ULNRC-06109

**DOCKET NUMBER 50-483
CALLAWAY PLANT UNIT 1
UNION ELECTRIC CO.
FACILITY OPERATING LICENSE NPF-30
RESPONSE TO REQUEST FOR ADDITIONAL INFORMATION RE: PR-03
AND PR-05, PROPOSED ALTERNATIVES FROM ASME OM CODE PUMP
AND VALVE TESTING REQUIREMENTS, AND WITHDRAWAL OF
RELIEF REQUEST PR-05. (TAC NOS. MF2786 AND MF2788)**

Response to Request For Additional Information (RAI) Regarding Relief Requests PR-03 and PR-05, Proposed Alternatives from ASME OM Code Pump and Valve Testing Requirements

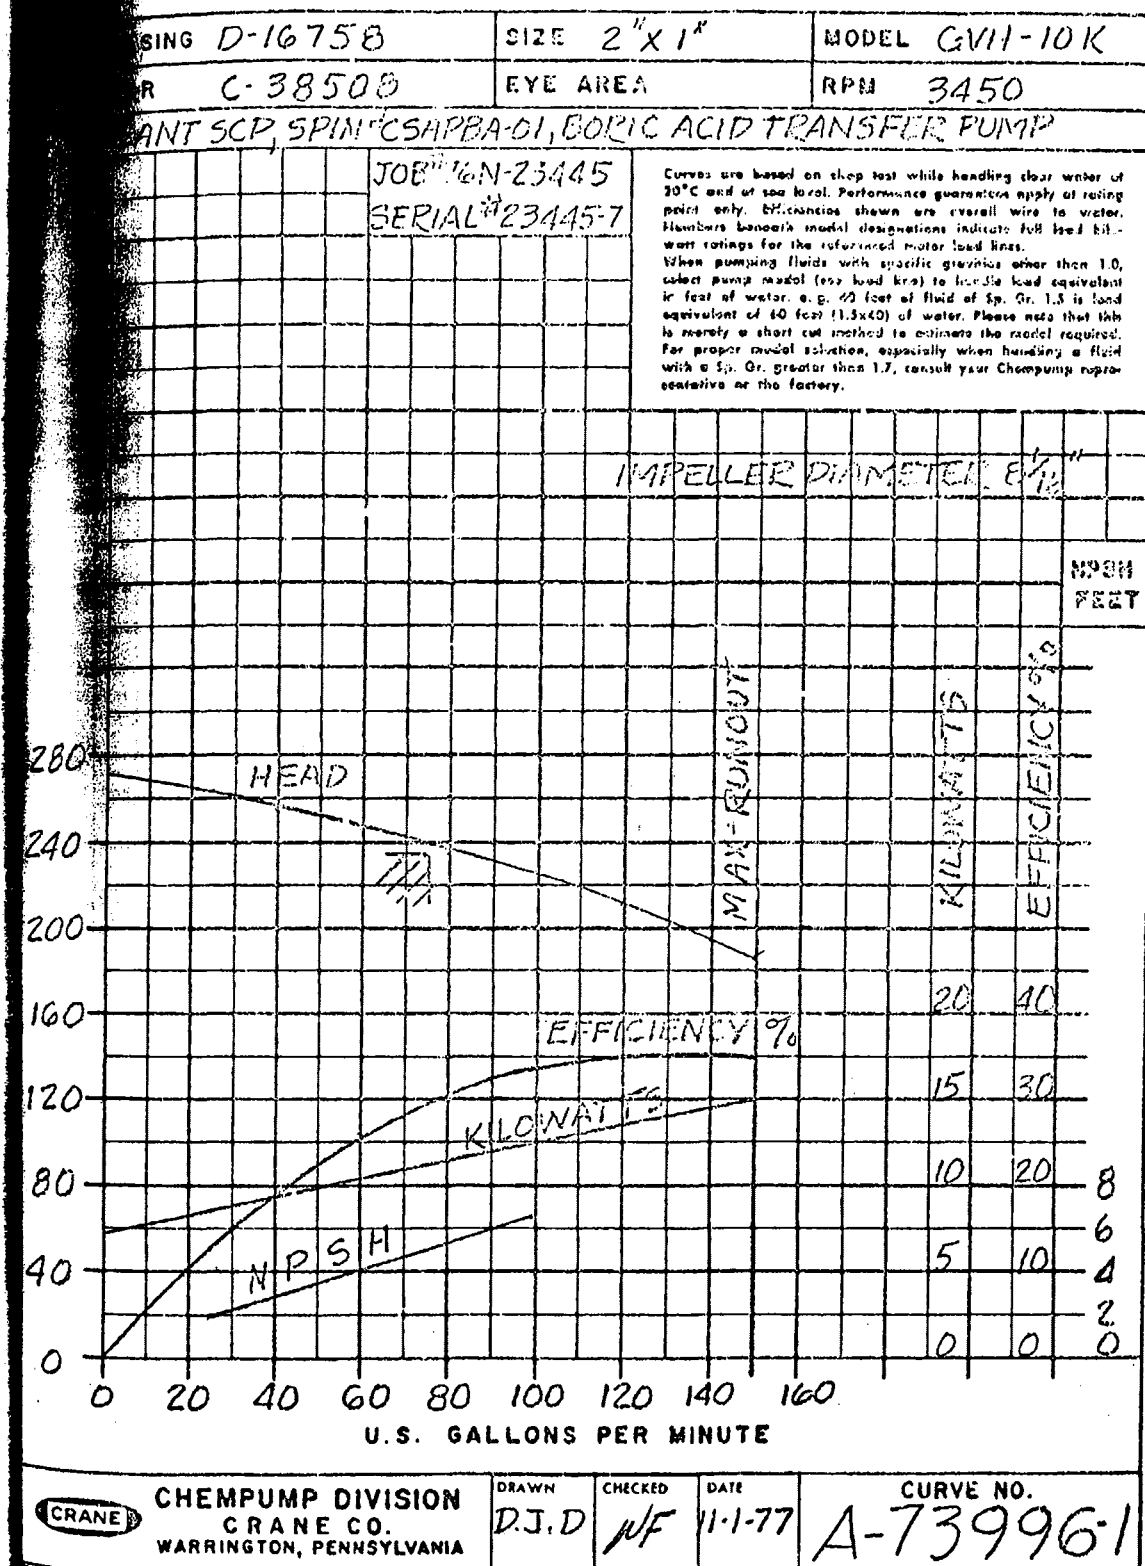
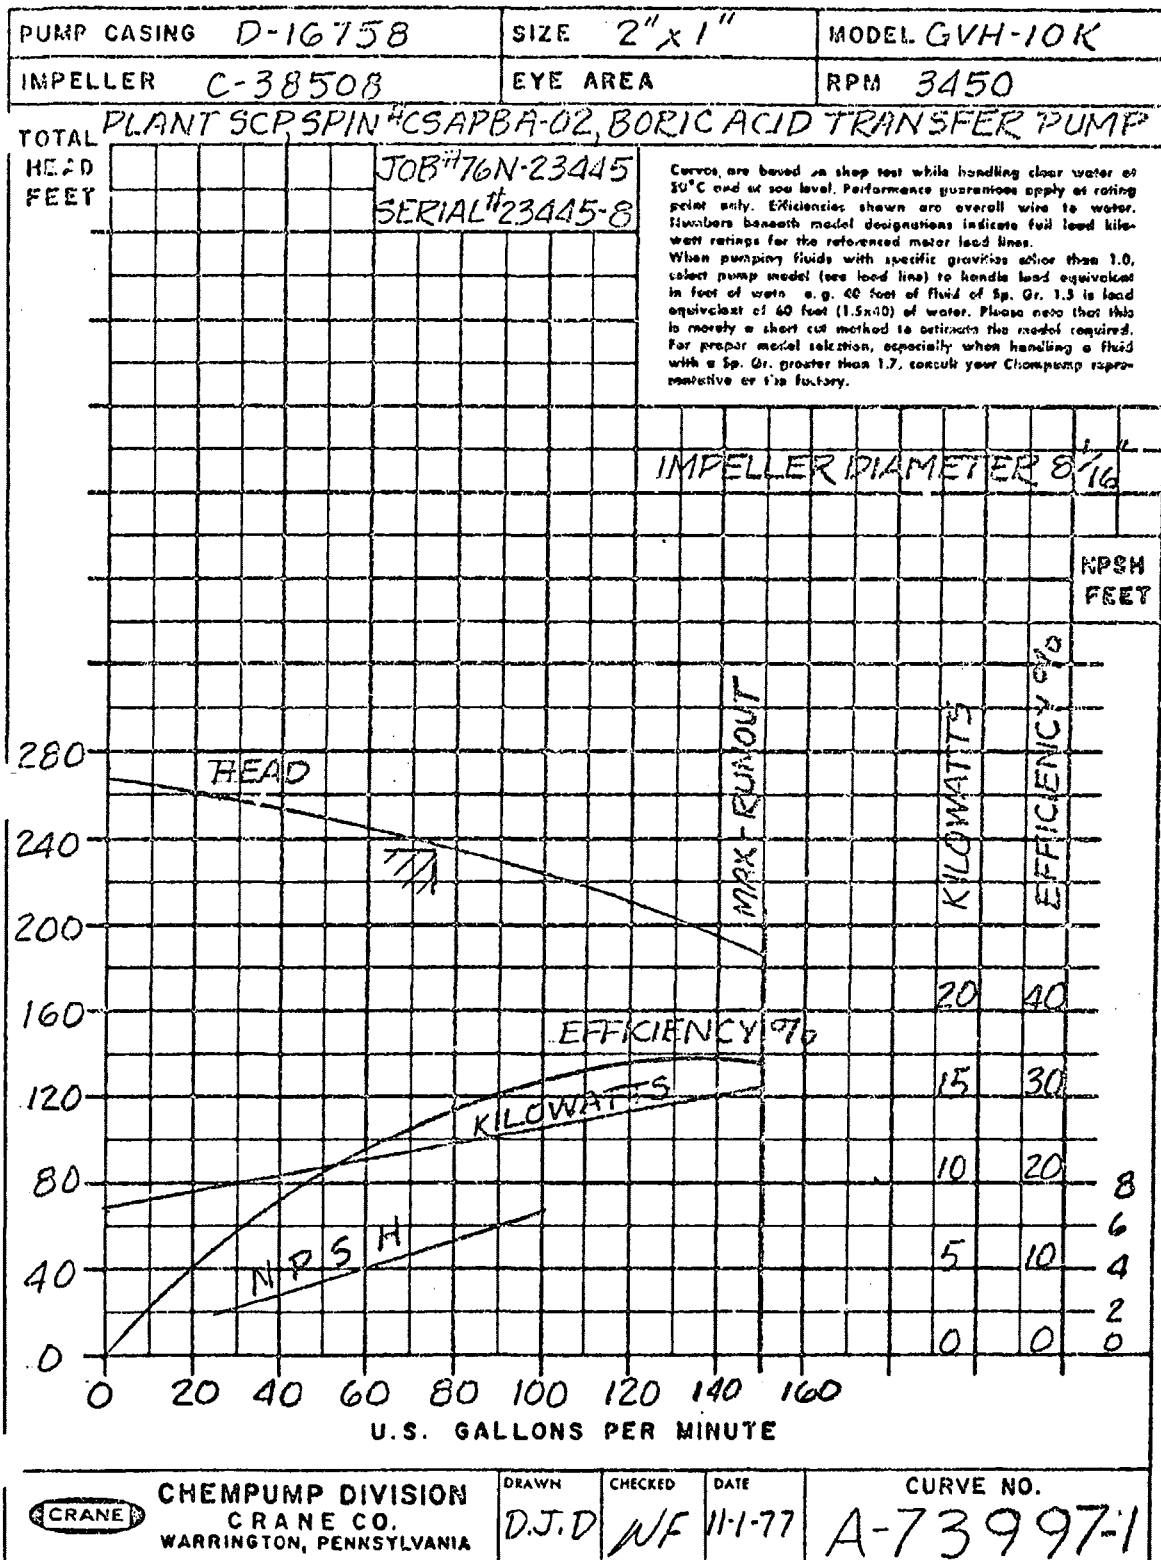
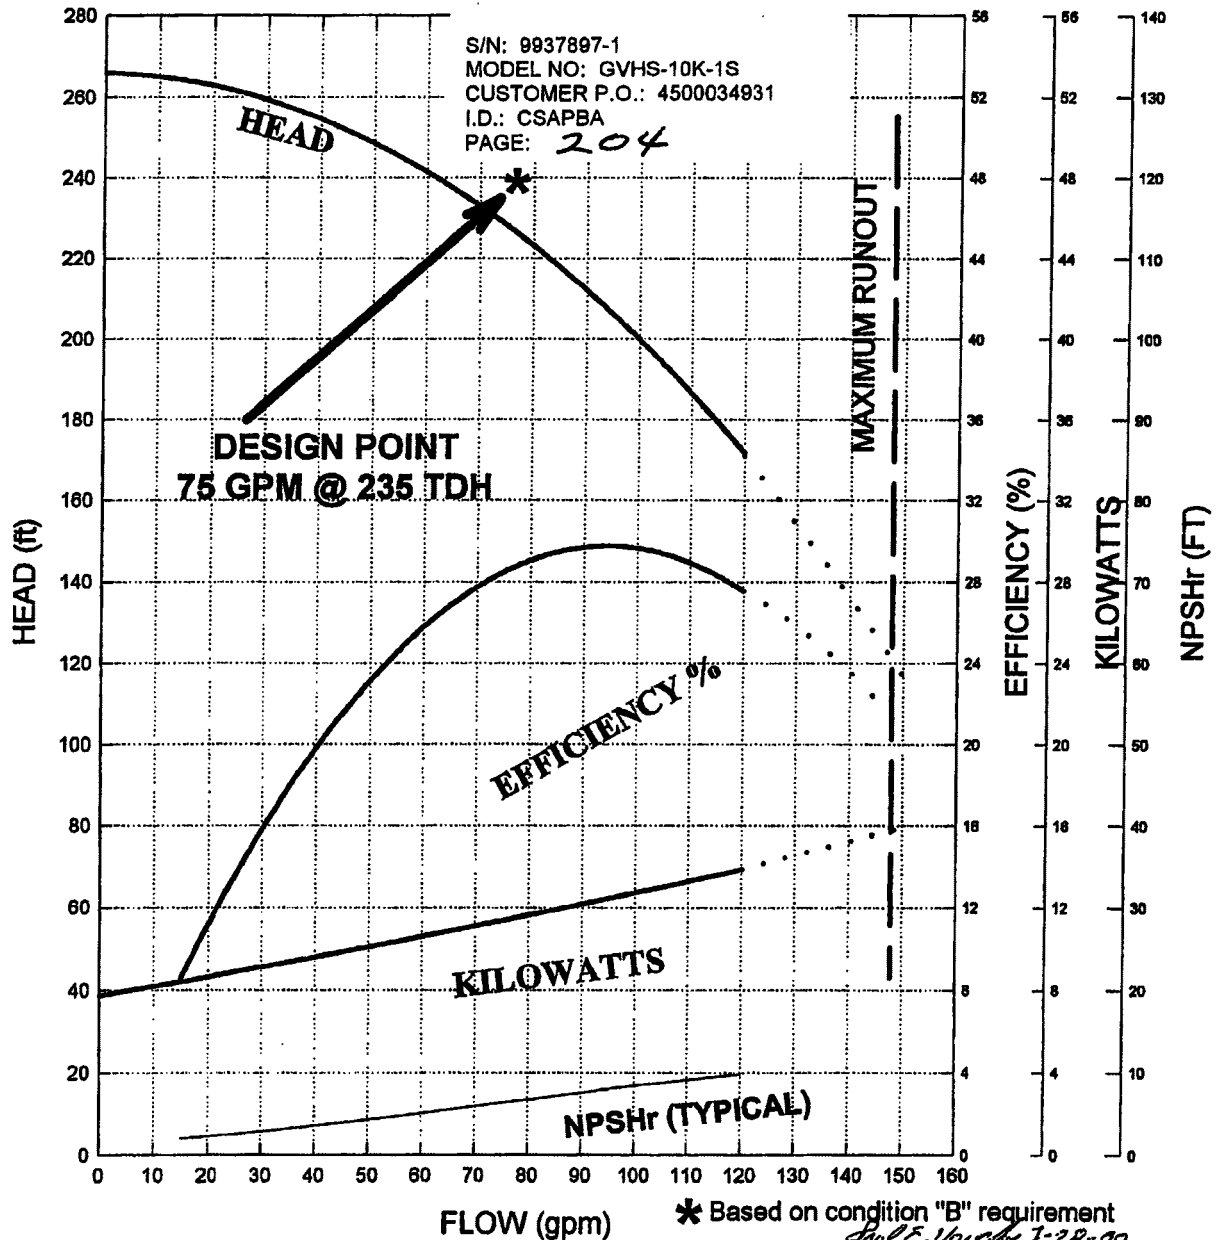
Provide a pump curve for the Boric Acid Transfer Pumps. If the pumps are operating at 15 gpm, are they operating on a flat portion of the curve or a sloped portion of the curve? If they are operating on a flat portion of the curve, discuss how pump degradation can be detected from the proposed Group A test results if flow is not measured.

Pump curves have been attached with this response. At 15 GPM the pump curves do exhibit some degree of slope/linearity, although not nearly as linear as the 75GPM bi-ennial CPT flow. The lack of flow measurement during quarterly testing does not prevent the detection of pump degradation. Because the throttle position of the applicable globe valve is administratively controlled, the flow rate for the quarterly testing is essentially a fixed value. This is no different than a typical test scenario where flow is measured and adjusted to a fixed reference value.
